Sprocket adaptor plate bolt substitution for 1999 models affected by Safety Recall V-06-07

This information is specific to model year 1999 motorcycles with original equipment rear cast wheels. See detail below.

1999 Wheel (RH hub)
(5) M10x1.5 threaded holes
(25mm depth) need different
bolts 7518032

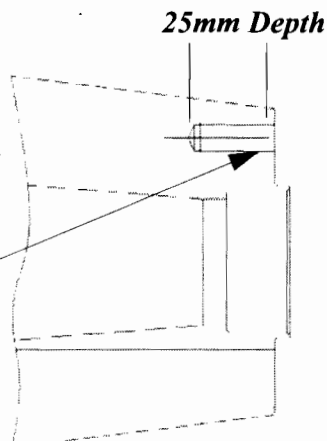
If you inspect a 1999 model and determine it needs the cushion drive rear hub as described on Safety Recall V-06-07, **you must order rear sprocket hub adaptor bolts P/N 7518032 (Qty 5) separately.** For model year 1999, the (5) M10x1.5 in the rear wheel hub for attachment of the rear sprocket have 20mm less thread depth than later model year Victory motorcycles. This shallower thread depth will not allow full engagement of the (5) new bolts (55mm long) included in kit 2876257.

2000-2001 Wheel (RH hub)
(5) M10x1.5 threaded holes
(45mm depth) use bolts in
kit, no changes required.

- If you are installing the Cushion Drive kit on a 1999 model year motorcycle, discard the (5) bolts (PN 7518146 M10 x 55mm long) included in the kit.
- Order (5) replacement bolts (PN 7518032 M10 x 35mm long)

- Do not use liquid Loctite[®] on new bolts (PN 7518032), as these new bolts have a pre-applied locking agent.
- Cleanliness of wheel hub threads is still required per original instruction (PN 9921130)
- No change to torque requirements for these bolts.
- No other changes to instructions required.

ORDER (Qty 5) Bolt, M10 x 35 (P/N 7518032)

Do not apply Loctite[®] 262 from kit
